**Reference: Proposed Sukunka Coal Mine Project - Response to Action Item #1 of the Caribou Sub-Working Group Meeting Held on October 16, 2018**

This memo provides a response to action item #1 and #3 from the caribou sub-working group meeting of the proposed Sukunka Coal Mine Project held on October 16, 2018 in Chetwynd, BC.

|  | <p>DATE: 05-NOV-18      PROJECTION: UTM 10</p> <p>FIGURE ID: 123110482      DATUM: NAD 83</p>   |   | <p>DRAWN BY: S PARKER</p> <p>CHECKED BY: P HAYWARD</p> |   | <p>FIGURE NO:</p> <p style="text-align: center; font-size: 24pt;"><b>1</b></p> |

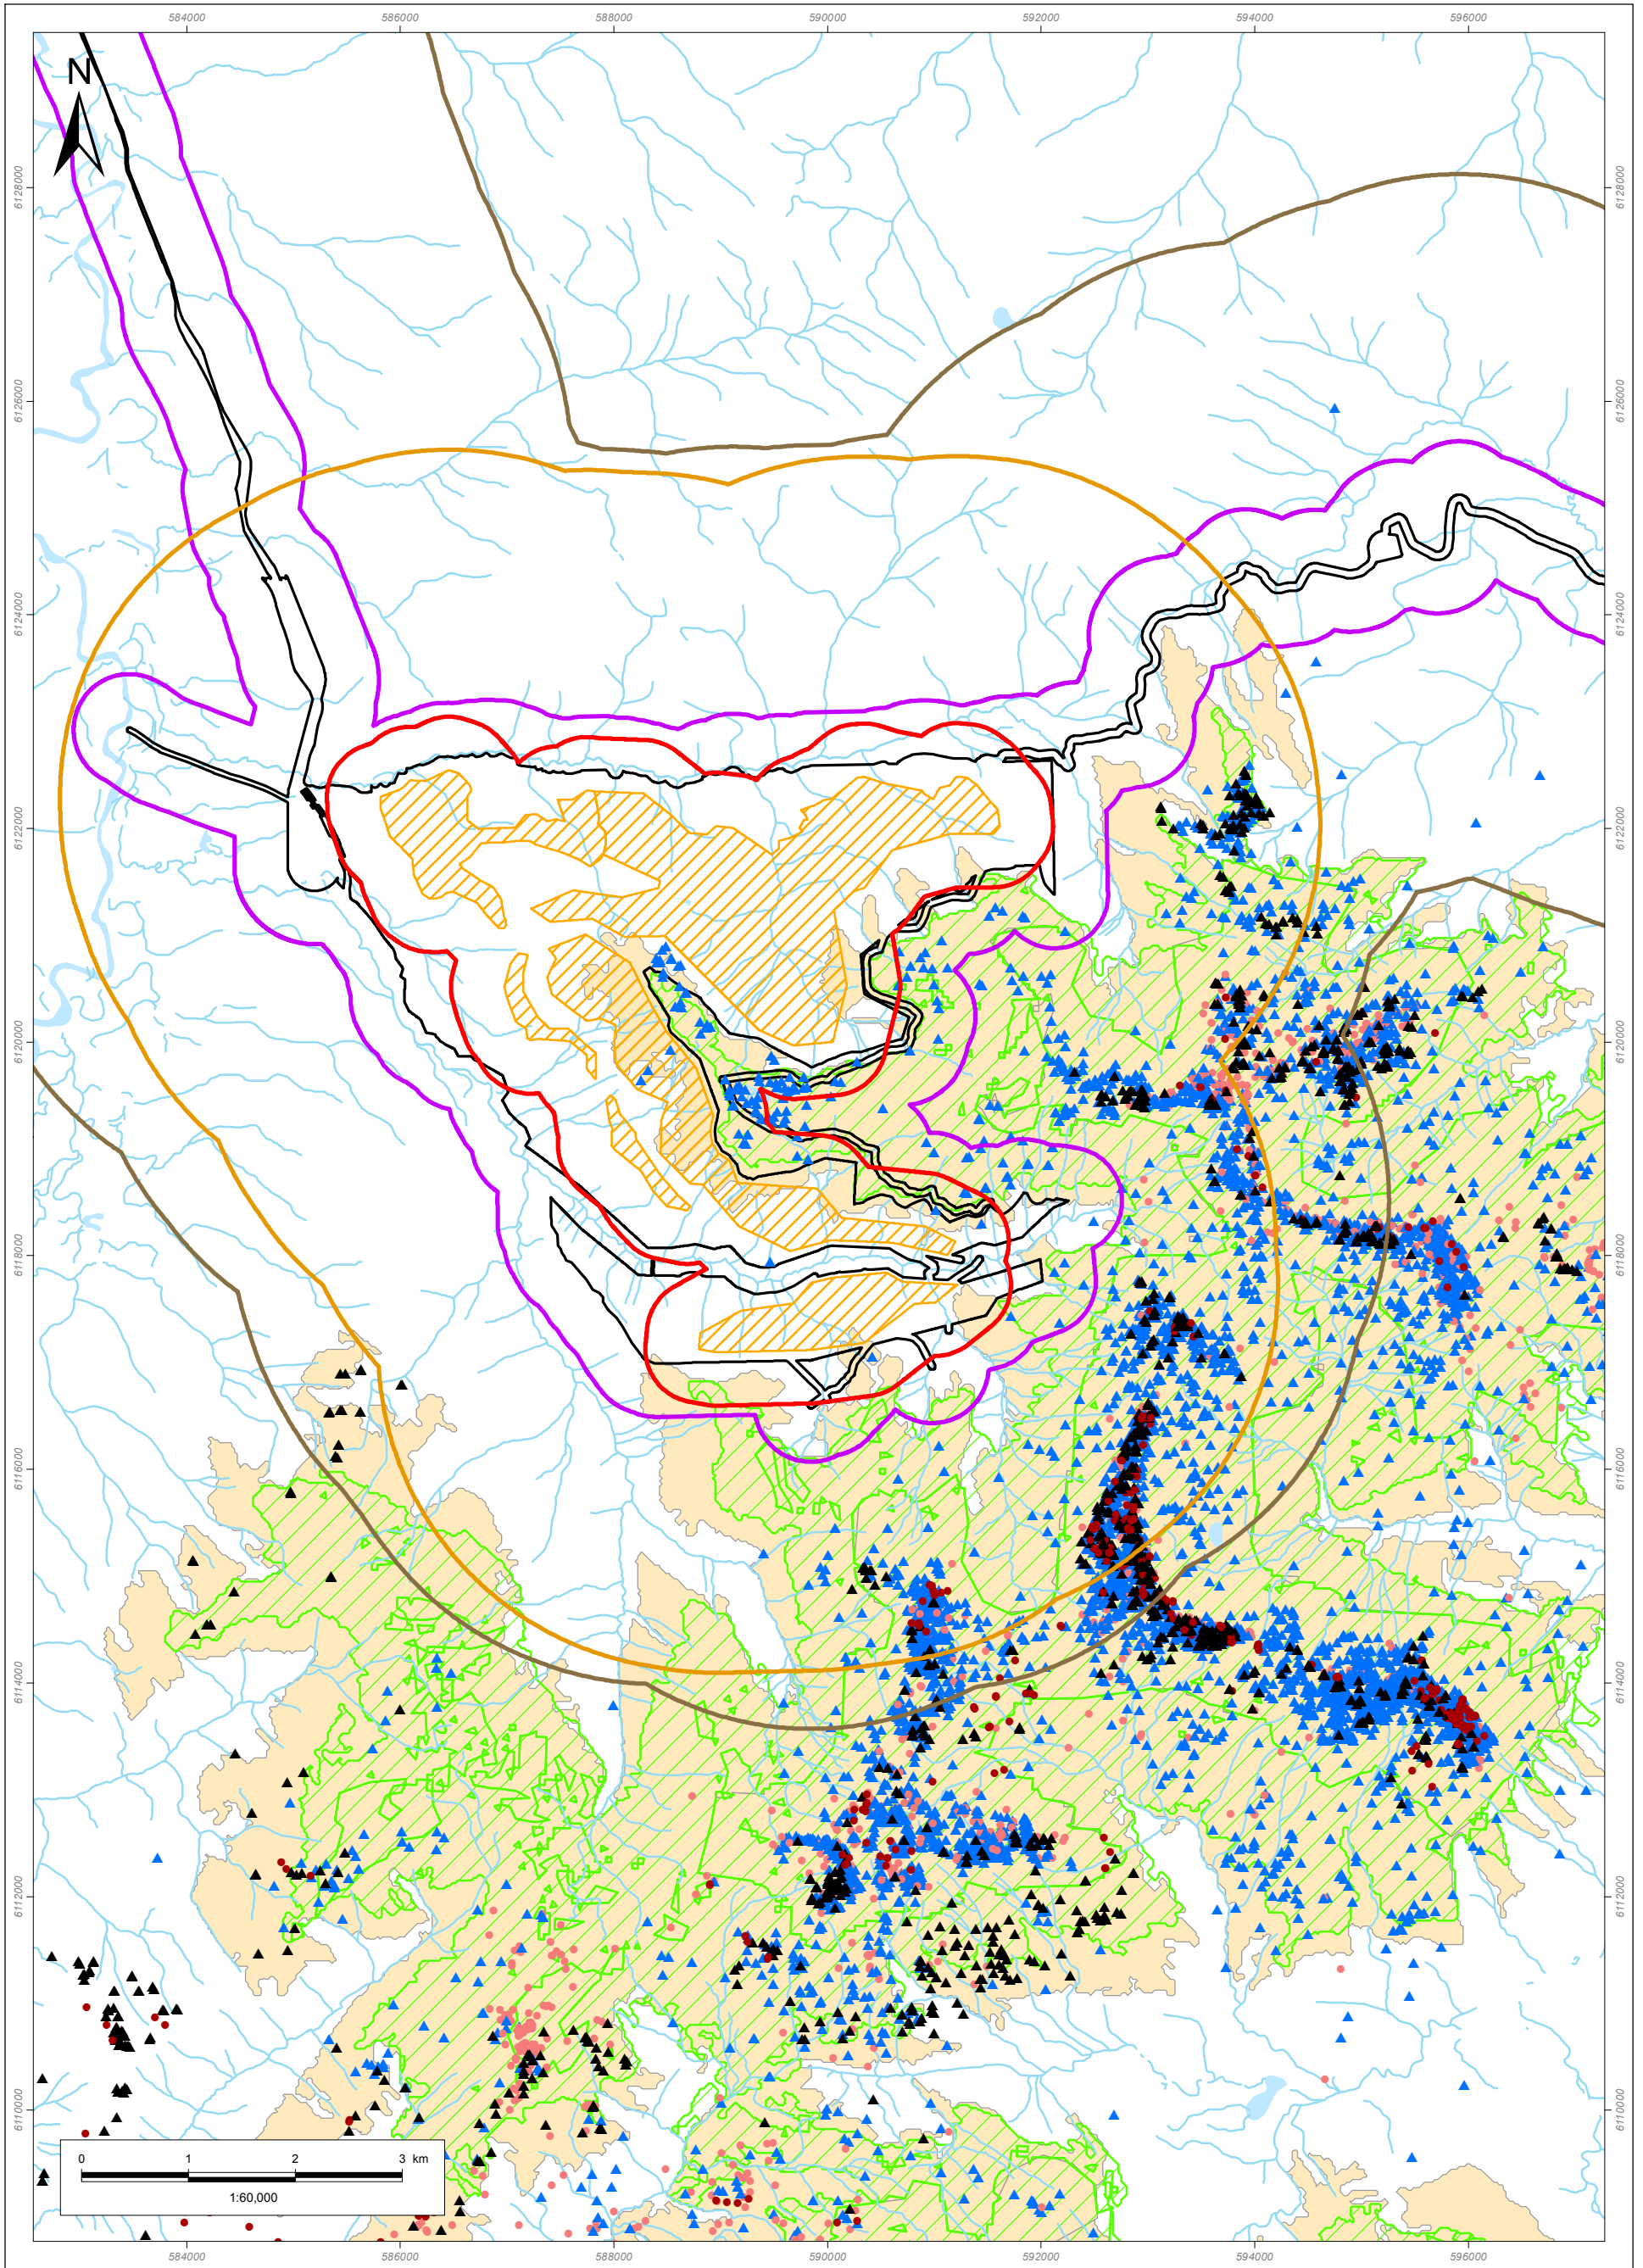
1. Figure showing the mine pits, environmental assessment (EA) boundary, 500 m and 3,000 m buffers, high elevation summer and winter ranges, and summer and winter caribou telemetry locations
2. Area of overlap of high elevation range within 500 m and 3,000 m of the mine pits in comparison to 500 m and 3,000 m buffers of the EA boundary
3. Caribou telemetry locations within 500 m and 3,000 m of the mine pits in comparison to 500 m and 3,000 m buffers of the EA boundary

Figure 1 shows the mine pits, EA boundary, buffers, high elevation winter range (HEWR), high elevation summer range (HESR), and caribou telemetry locations. To illustrate recent caribou use on Bullmoose and Chamberlain mountains, caribou telemetry locations are grouped into 'historic' (pre-2015) summer and winter, and 'recent' (2015-2018) summer and winter. Summer is April through October and winter is November through March.

The pit boundary results in overlap with fewer caribou telemetry locations compared to the EA boundary, most noticeably in winter (Table 2). There are few telemetry locations within 500 m of the pits or EA boundary, and those that overlap are winter locations pre-2015 (see Figure 1).

**Figure 2: Proposed Sukunka Coal Mine**

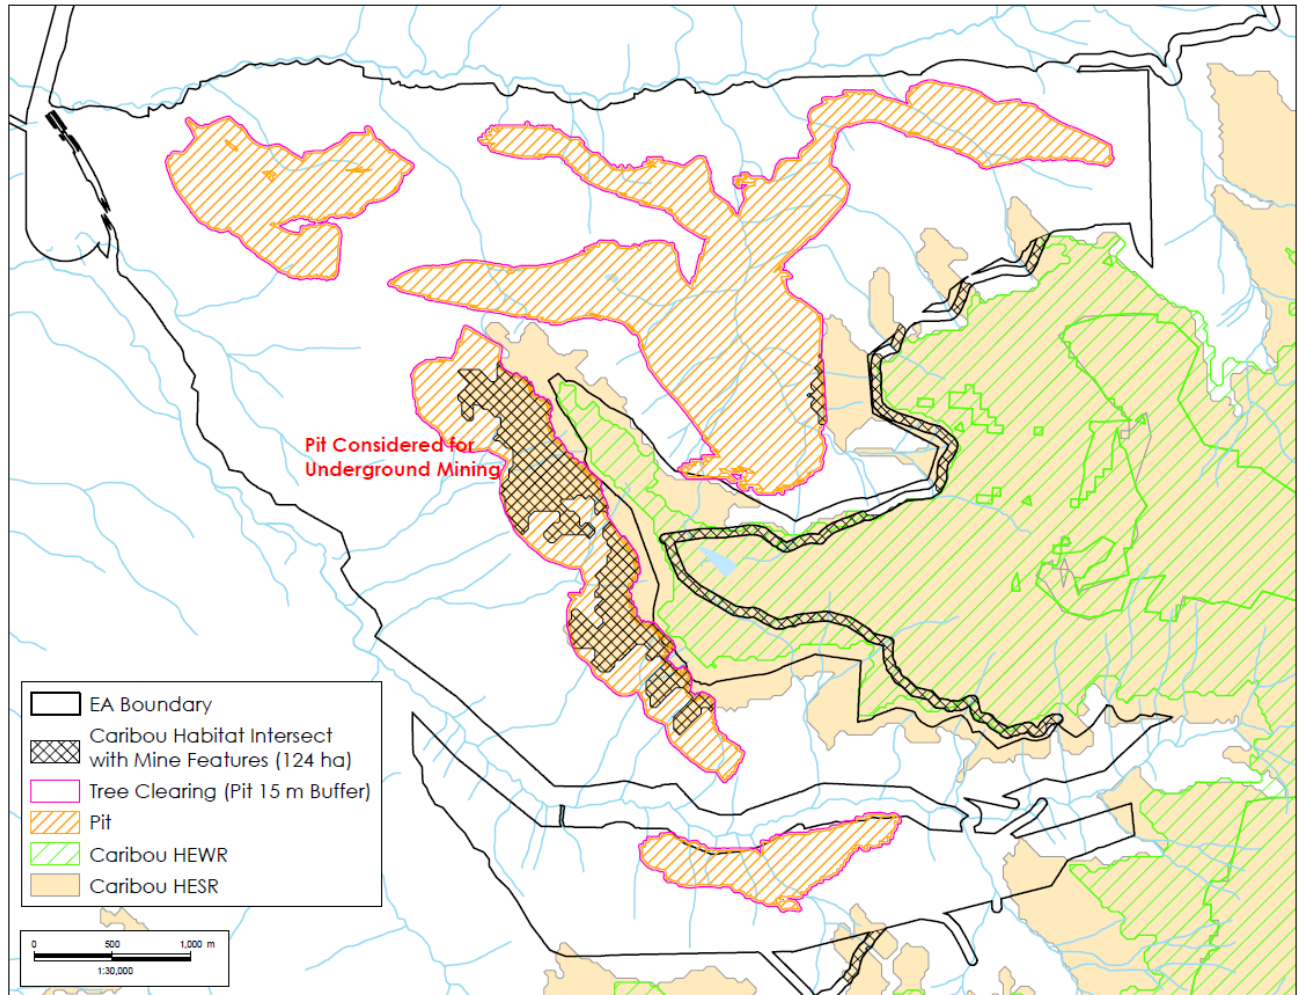
The caribou sub-working group requested Glencore to consider if current pits could be mined underground. Glencore has reviewed the geological modelling for the deposit and has specifically focussed on the open pit that directly overlaps the High Elevation Summer Range, as noted on Figure 2 below.

The open pit highlighted above follows along the topography in the area and the western edge of the pit starts at the outcrop of the coal seams. As a general rule of thumb underground mining is not technically feasible with less than 50 metres Depth of Cover (DOC), and approximately half of the pit has a DOC of less than 50 metres. For the remainder of the pit area, underground mining would be technically feasible, however the available underground area would be further reduced as the coal seams are truncated by a fault that runs parallel to the highwall. For these reasons open cut

extraction is the more efficient (both in terms of resource extraction and economically), and hence preferred, method of mining.
